CU Anschutz – Breckenridge Parking Lot Improvements

Project Number: 22-116457

Thursday, June 30, 2022
ADDENDUM 3

C-452

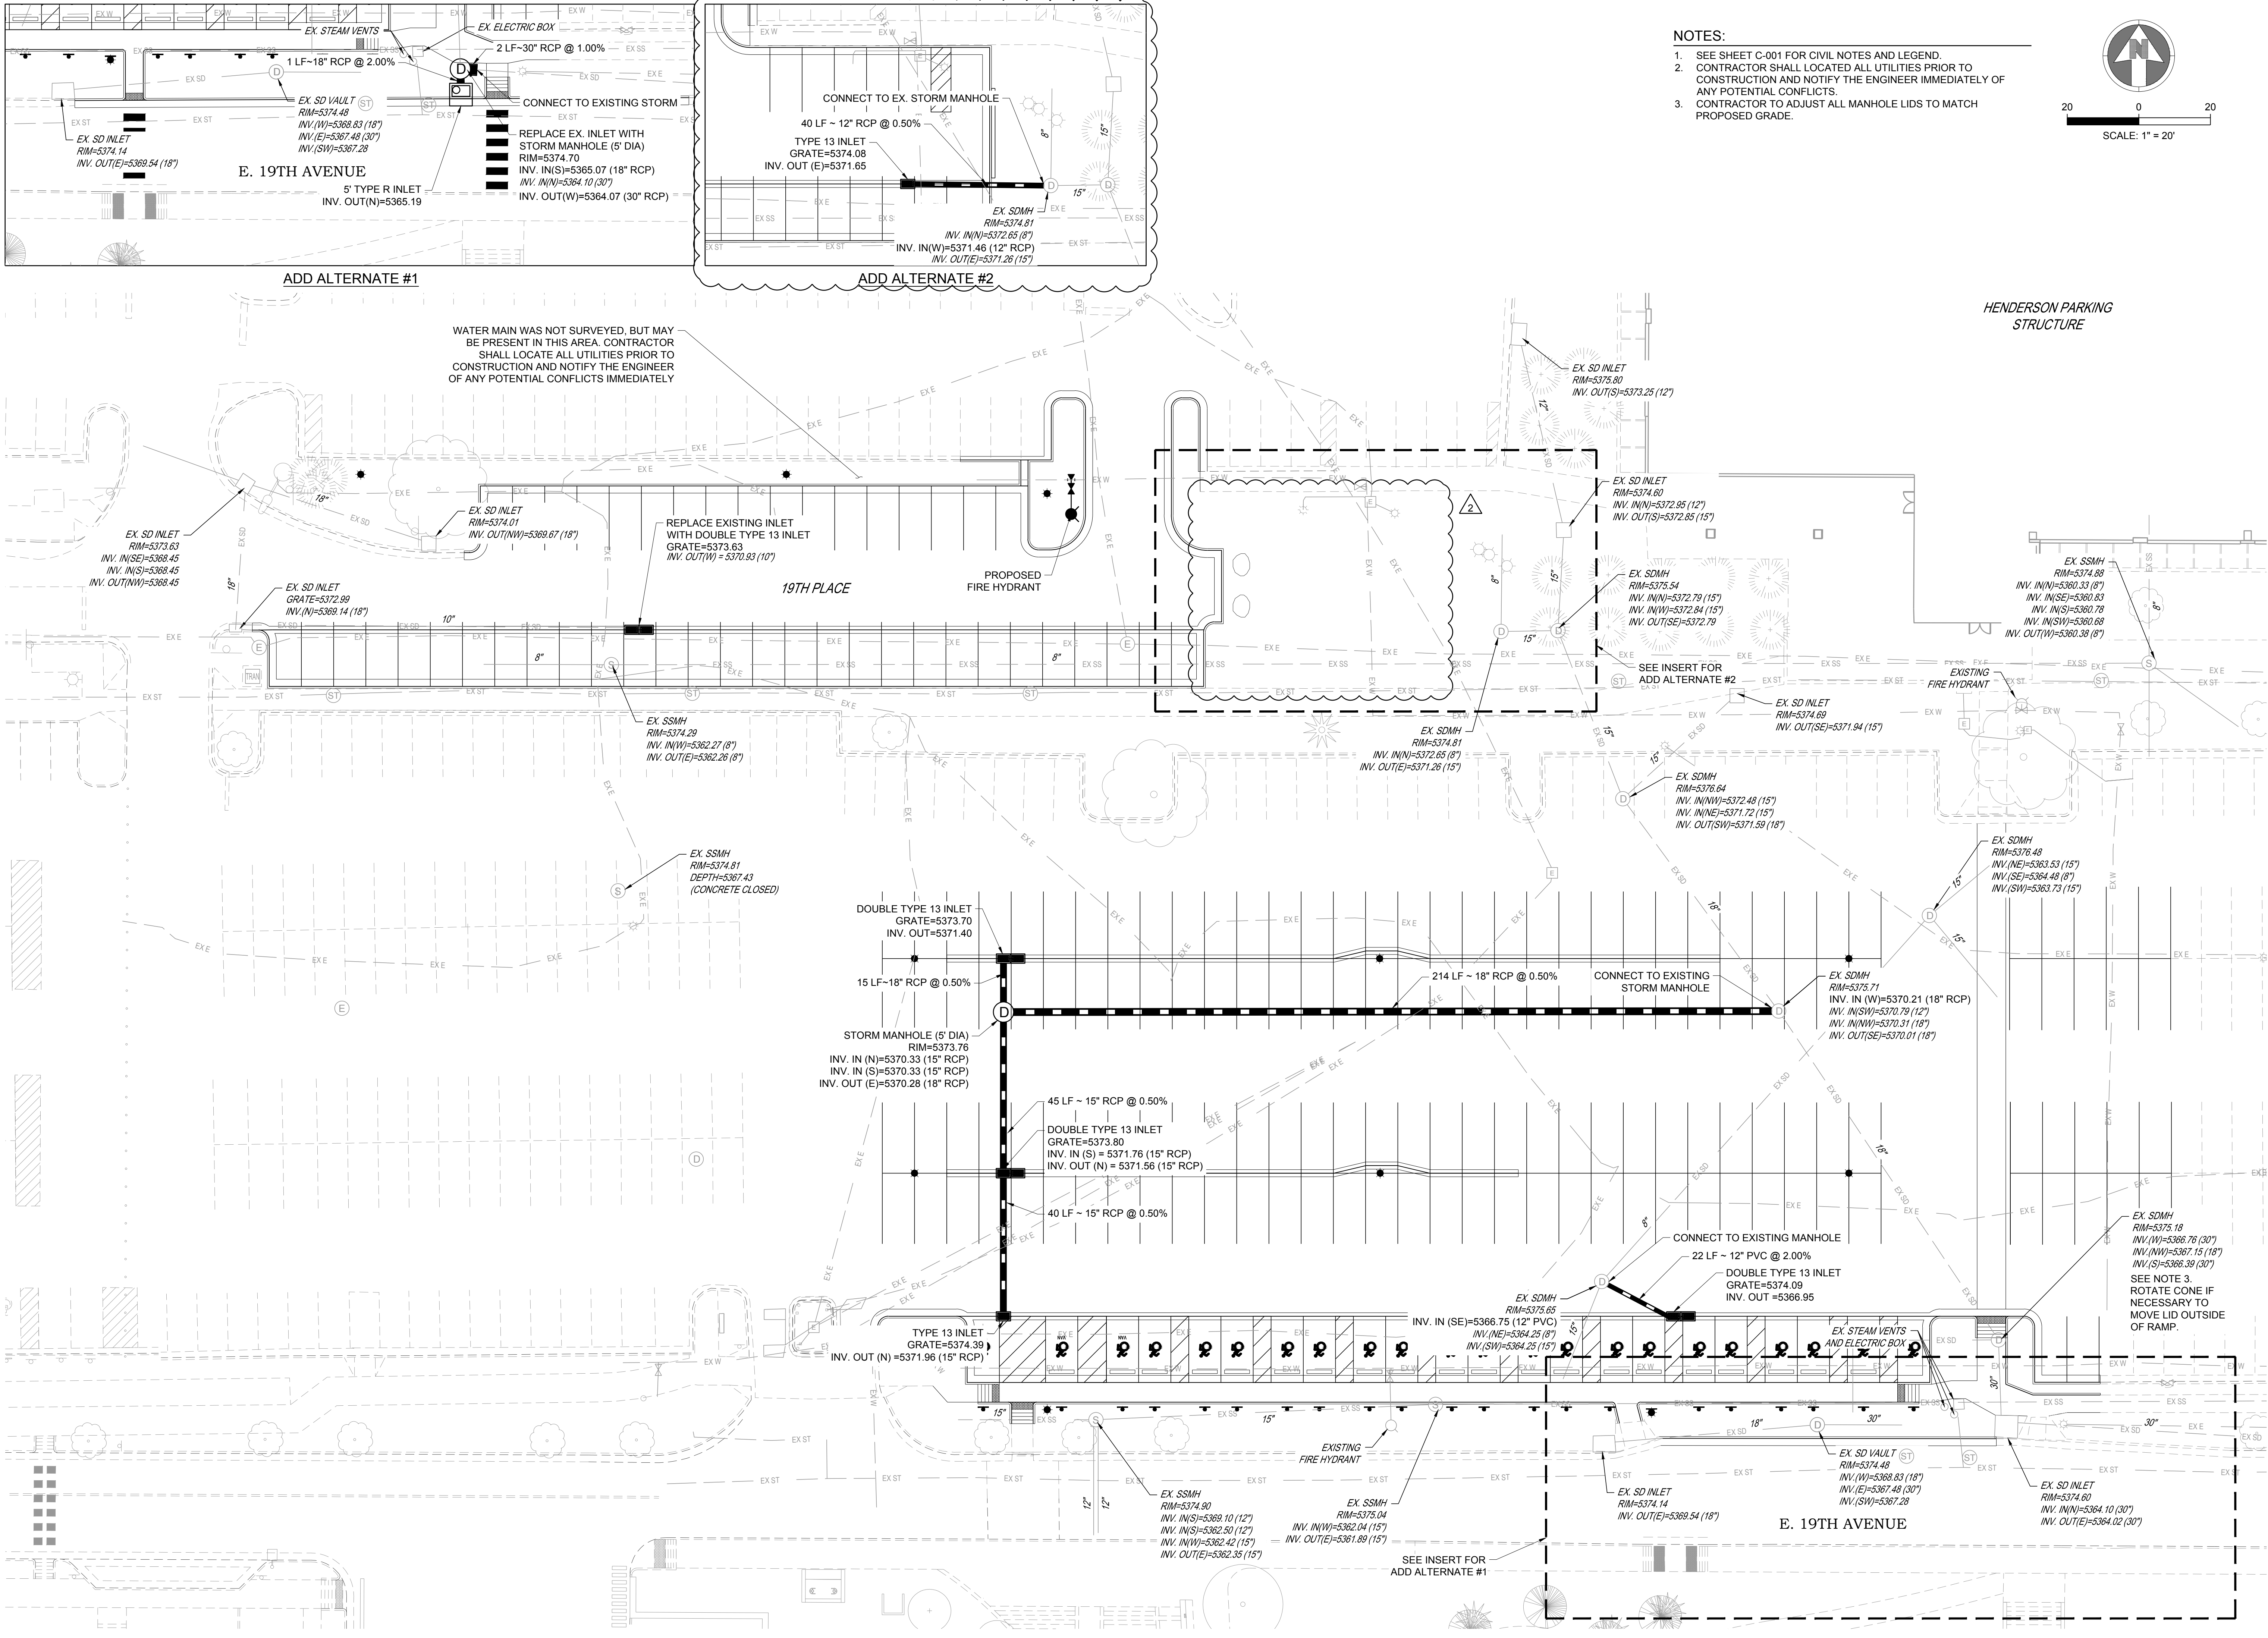
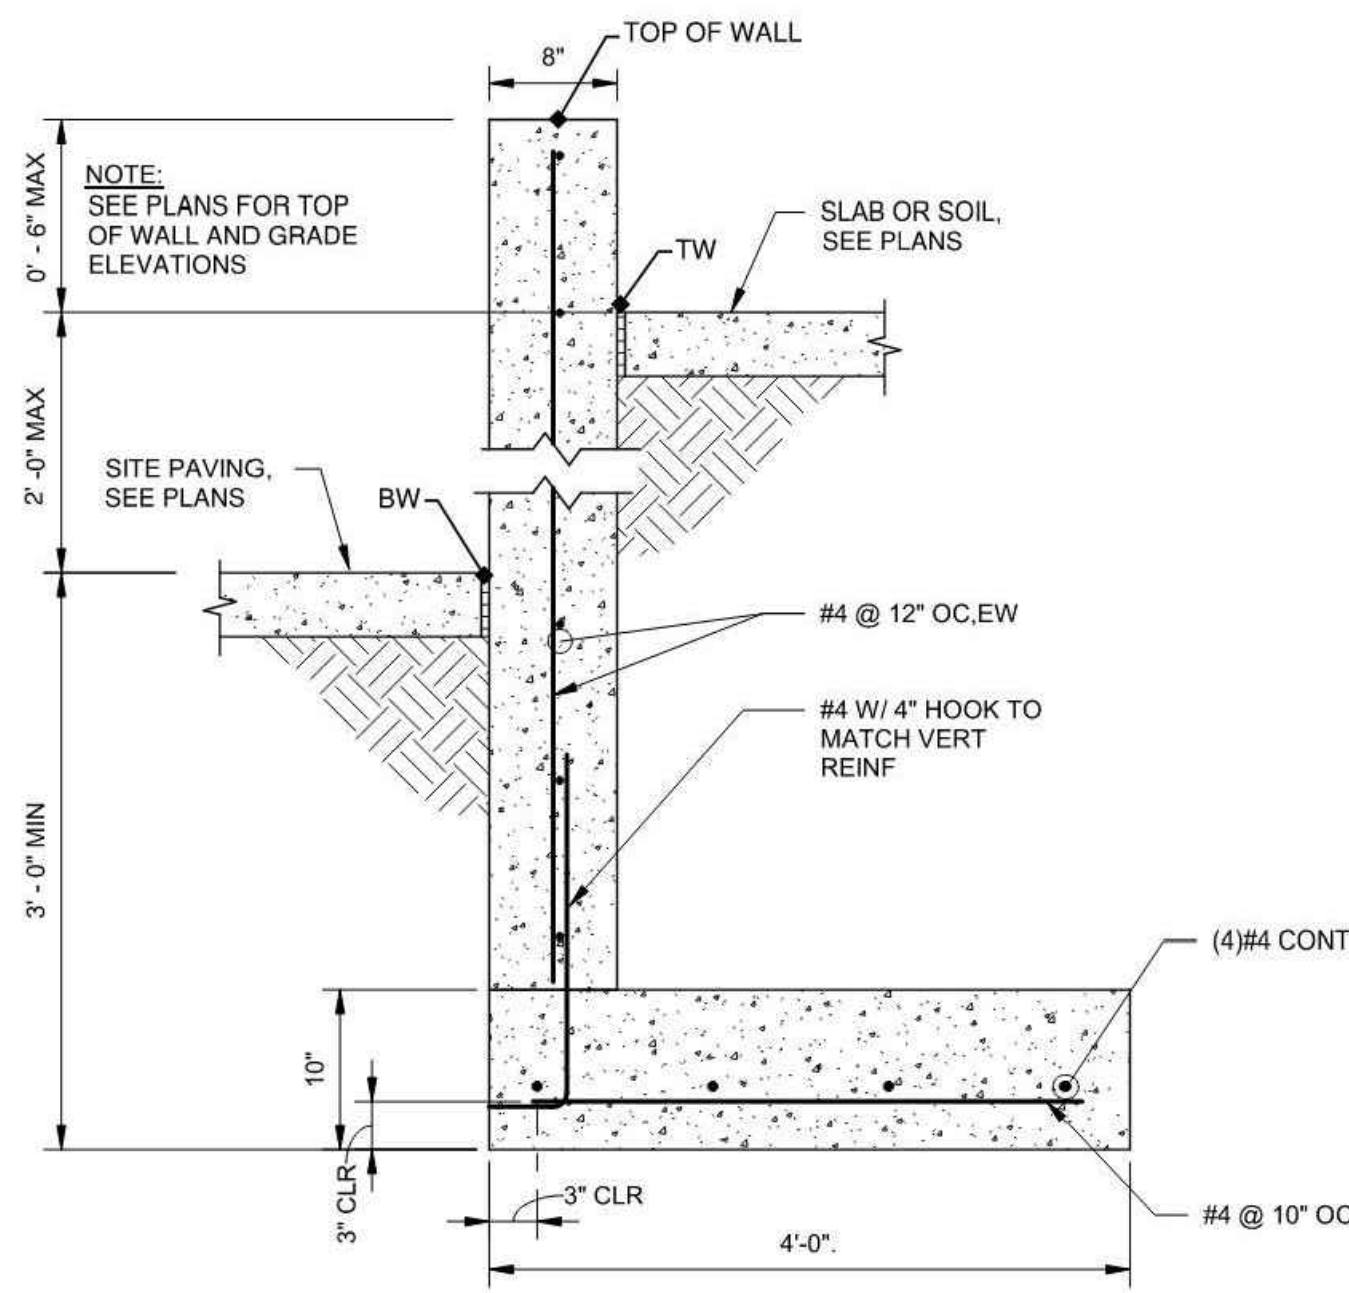
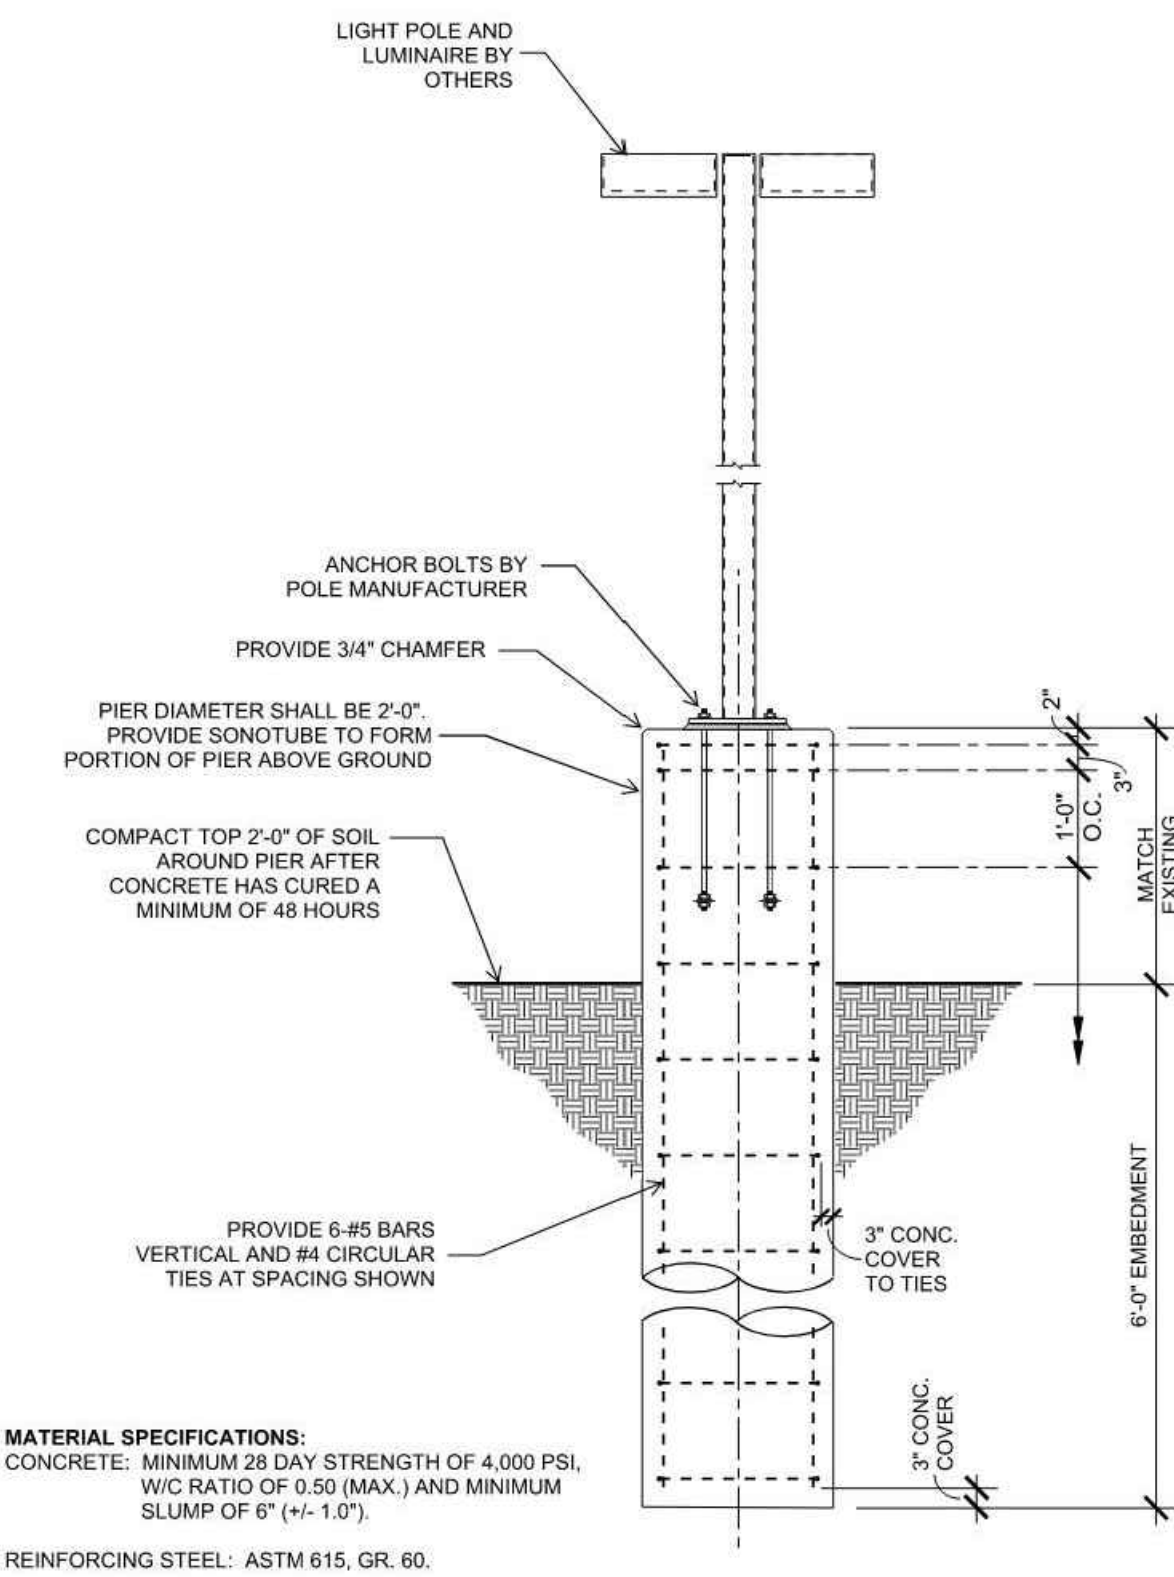
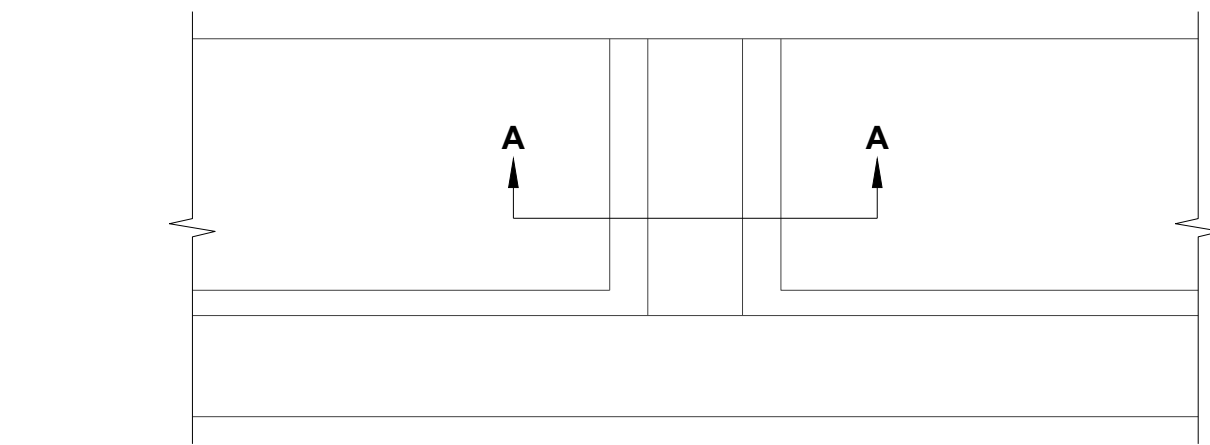
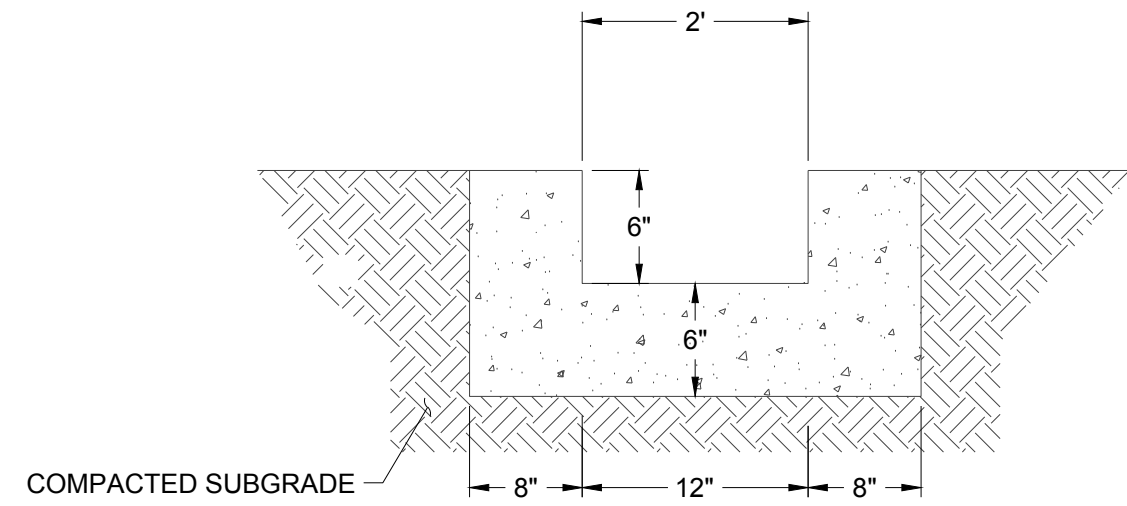
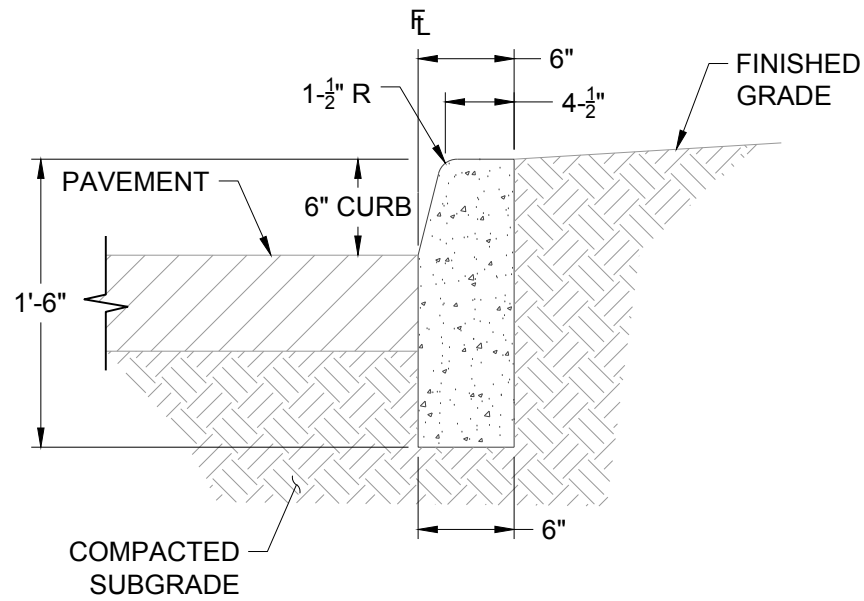
1. The following sheets have been revised to reflect an enlarged parking/snow storage area as a part of Add-Alternate 2:
 - a. C-101
 - b. C-121
 - c. C-211
 - d. C-411
 - e. C-421
 - f. C-452
 - g. C-511
 - h. ED-102
2. The following sheets have been revised to reflect comments from Pete Bloomquist, more specifically:
 - a. E-001: Removed house side shield from Luminaire Schedule and updated voltage to be Universal.
 - b. E-102: Circuit information added, revised keynotes
 - c. E-103: Circuit information added, revised keynotes
